HISTORIC AND DESIGN REVIEW COMMISSION

HDRC CASE NO: 2022-153
ADDRESS: 303 DEVINE ST
LEGAL DESCRIPTION: NCB 725 BLK 7 LOT S 85 FT OF 6 & S 85 FT OF W 25 FT OF 7
ZONING: R-6, H
CITY COUNCIL DIST.: 1
DISTRICT: Lavaca Historic District
APPLICANT: Kyle Peebles
OWNER: Kyle Peebles
TYPE OF WORK: Driveway Gate
APPLICATION RECEIVED: February 18, 2022
60-DAY REVIEW: Not applicable due to City Council Emergency Orders
CASE MANAGER: Hannah Leighner

The applicant is requesting a Certificate of Appropriateness for approval to install an inward-swinging, cattle fence-style, automatic vehicle gate at the front of the driveway in the rear yard.

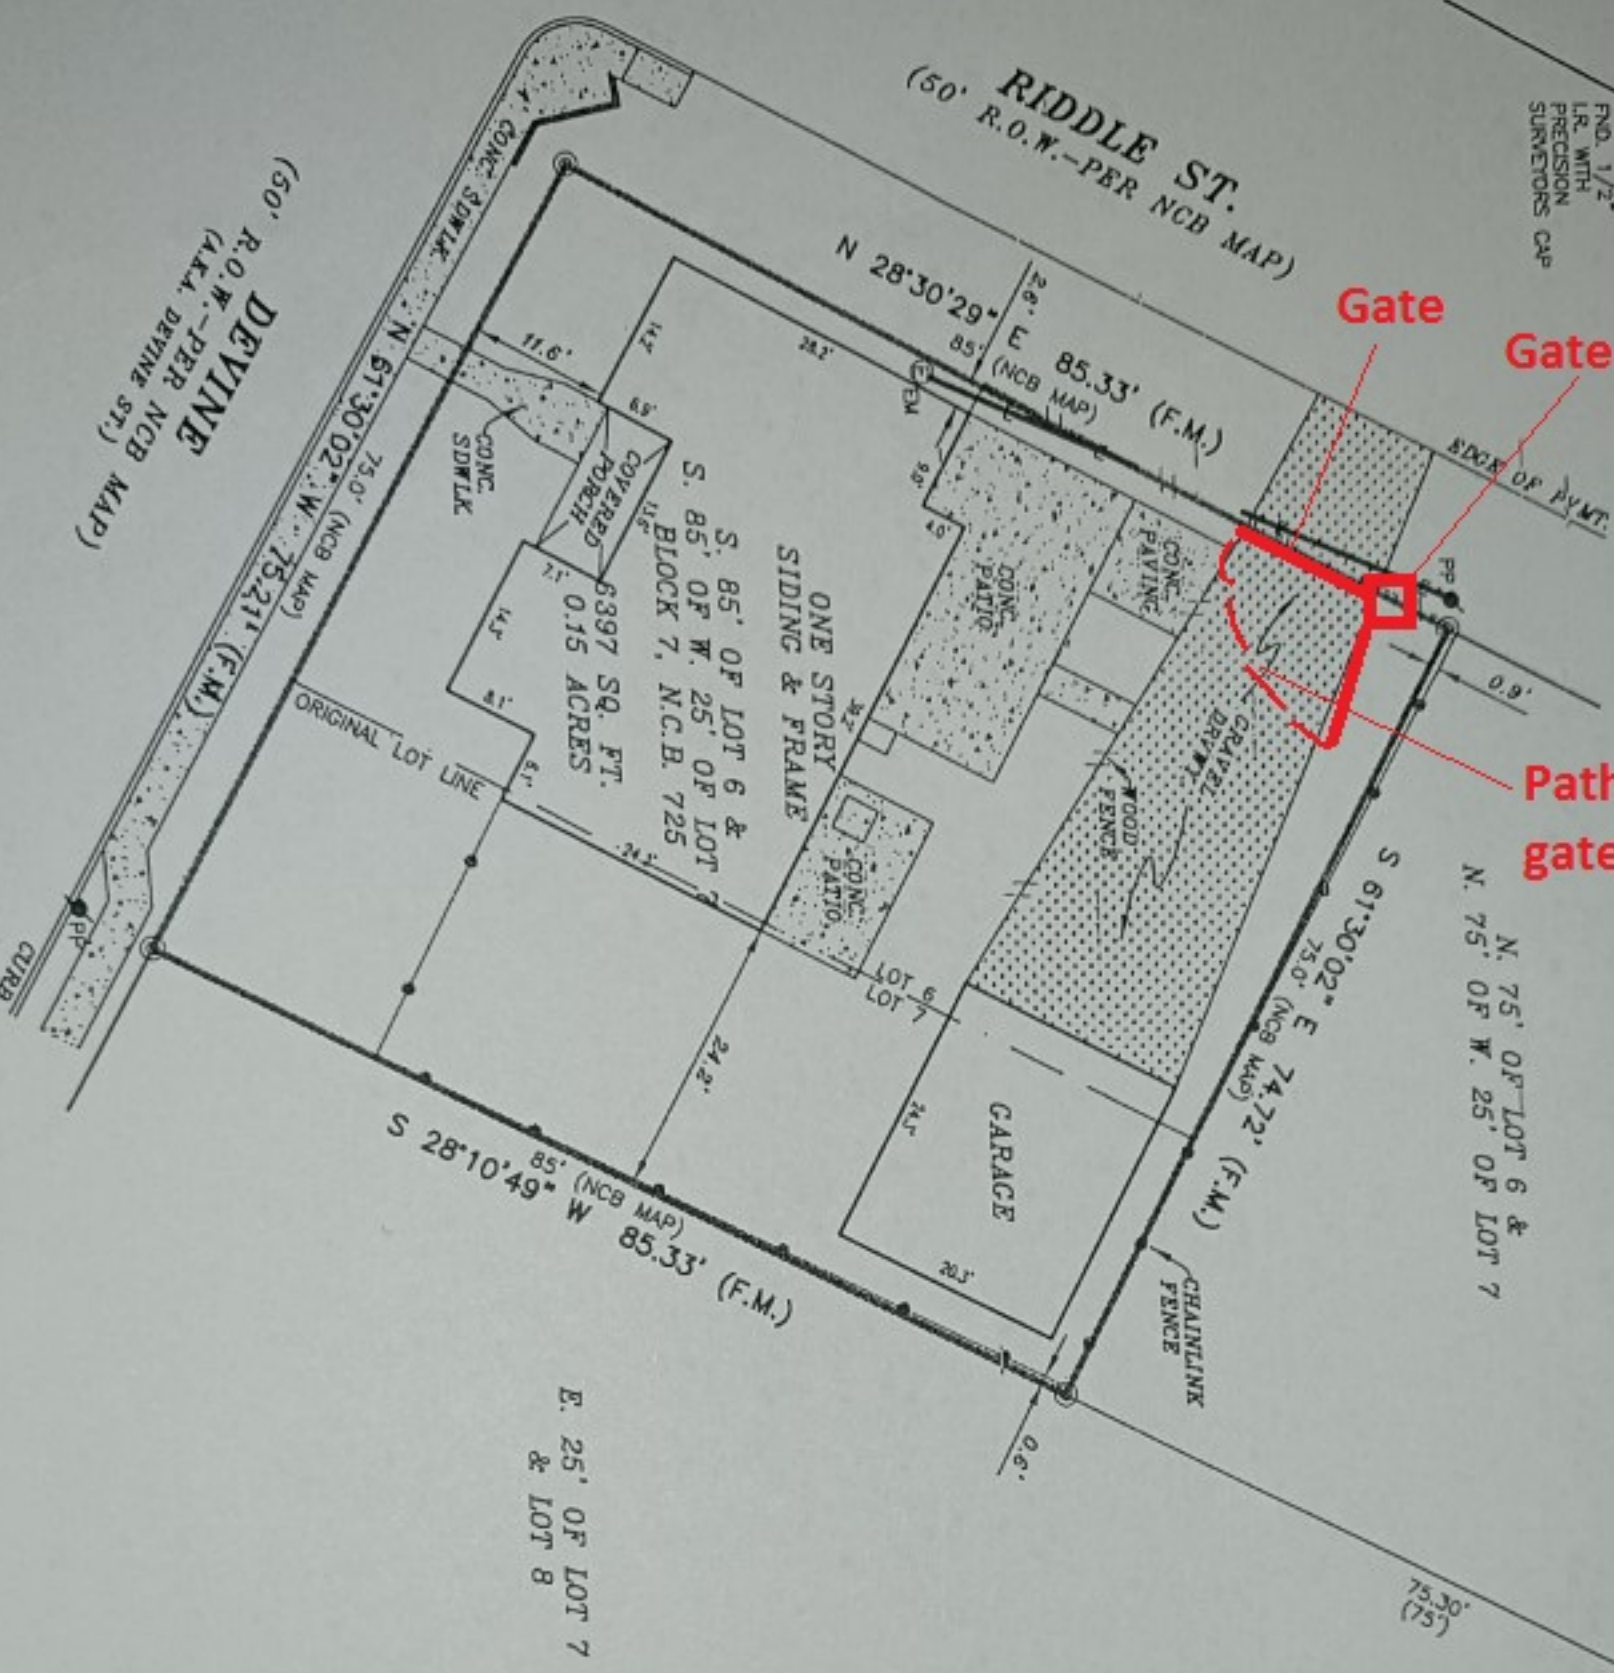
- b. VEHICLE GATE INSTALLATION – The property is located at the corner of Devine St and Riddle St; the rear yard runs along Riddle St from which the detached garage is accessed. The property currently features a 6-foot wood privacy fence in the rear yard. The applicant is proposing to continue the fencing across the driveway to connect to the rear chain link fence by installing a vehicle gate at the driveway facing Riddle Street. The Historic Design Guidelines for Site Elements, 2.B.i states that new fences should only be installed where they have historically existed. The proposed gate location connects an existing wood fence and does not change the current fencing setback. Staff finds the proposed driveway gate installation to be appropriate. The applicant is requesting approval to install a cattle fence-style, automatic vehicle gate. The Guidelines for Site Elements 2.B.i states that new fences and walls should appear similar to those used historically within the district in terms of their scale, transparency, and character. Fences should be designed to respond to the design and materials of the house or main structure. Staff does not find the cattle-fence style gate to be consistent with these Guidelines; a wood gate or wrought iron gate would be appropriate.

Staff recommends approval of item 1 based on finding b with the stipulation that the gate is composed of wood or wrought iron, and that the final gate design is submitted to staff for review prior to approval.
